CERTIFICATE OF APPROPRIATENESS

Property: 1418 Ashland Street, Lot 25, Tract 24 and 26A, Block 152, Houston Heights Subdivision. The property includes a historic 1,194 square foot single family residence situated on a 8,712 square foot (66' x 132') interior lot.

Proposal: Alteration – Addition

Recommendation: Denial - does not satisfy criteria

NORTH ELEVATION – FRONT FACING ASHLAND STREET

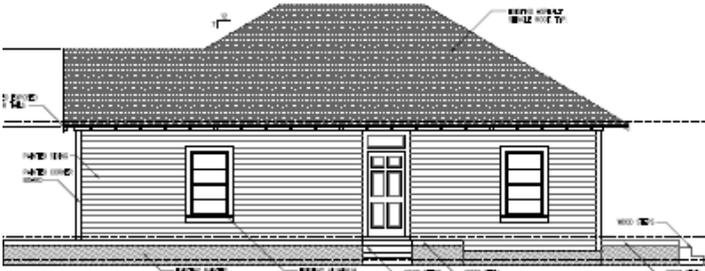
<i>The proposed addition visually overwhelms the character of the original structure. The taller and wider mass of the addition, and the location of this mass so close to the public right-of-way, diminishes the appearance of the shorter and narrower existing structure.</i></p> |

<i>The proposed use of tapered columns on brick piers for the front porch restoration is not substantiated by any historical, physical, or pictorial evidence. If there is no evidence demonstrating what porch columns previously existed, a more appropriate column choice would be a simpler square or round column.</i></p> |

NORTH SIDE ELEVATION

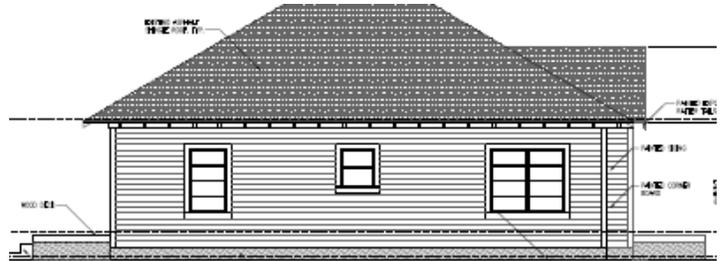
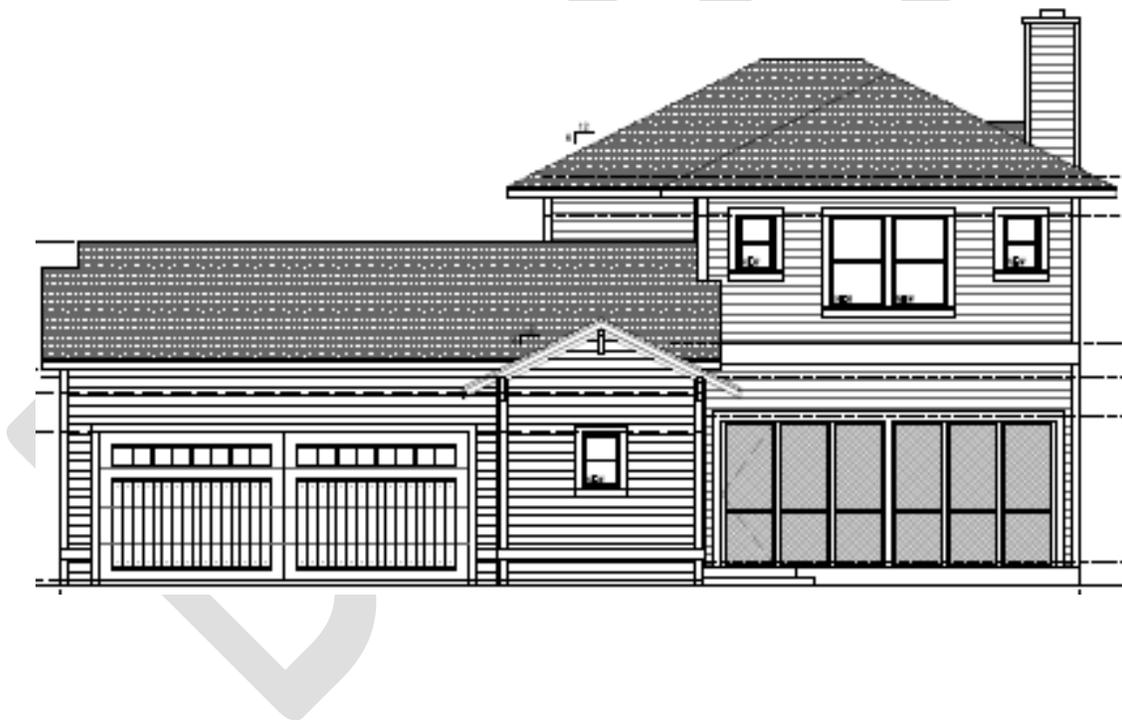
<i>The proposed taller and substantially wider addition is of an incompatible scale than the existing historic residence. This is compounded by the fact that the second story mass and south side of the addition are situated relatively close to the public right-of-way. This condition can be alleviated by locating the two-story portion of the addition at the rear of the lot and locating the proposed south side addition to the northeastern corner of the lot, which</i></p> |

Side Elevation: The applicant proposes to replace four non-original aluminum windows with five wood 1-over-1 windows. The window opening at the rear of the north elevation will be widened to convert the window opening from single to double. Staff inspection found that the structural wall material at the proposed opening has long since been removed meaning the enlarged opening will not result in the loss of historic materials.

is currently proposed to be open space.

**HISTORIC STRUCTURAL WALL MATERIAL PREVIOUSLY REMOVED AT PROPOSED
NEW WINDOW OPENINGS
EXISTING WINDOWS C AND D**

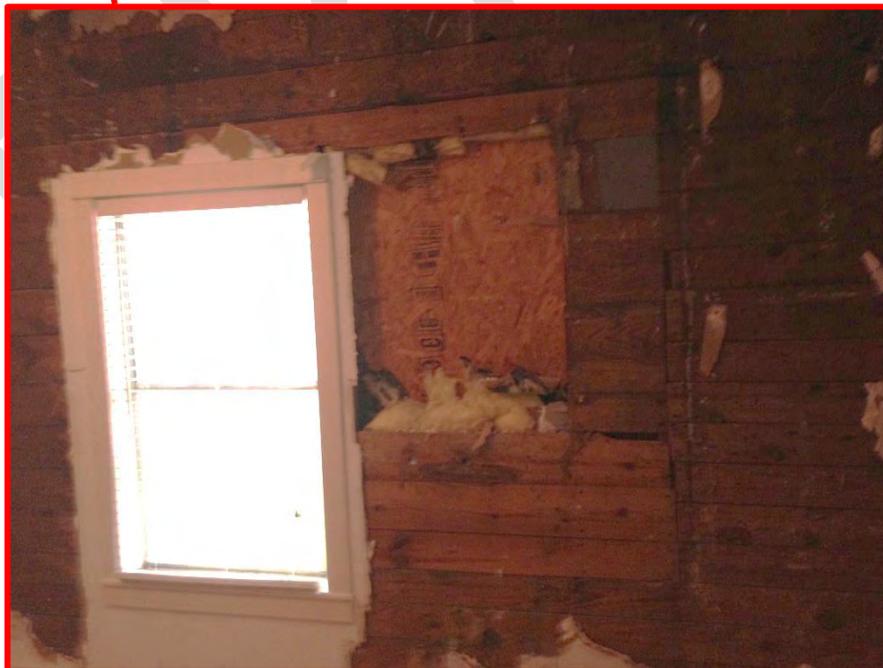
Windows/Doors: The existing residence features non-original wood and aluminum windows. The applicant proposes to replace all of these windows with wood 1-over-1 double hung windows. Three of the proposed windows will be installed in enlarged window openings. The applicant has removed sections of interior drywall around the proposed new window openings to reveal that the historic wall material has been altered or removed entirely, so no historic material will be lost as a result of the new openings.
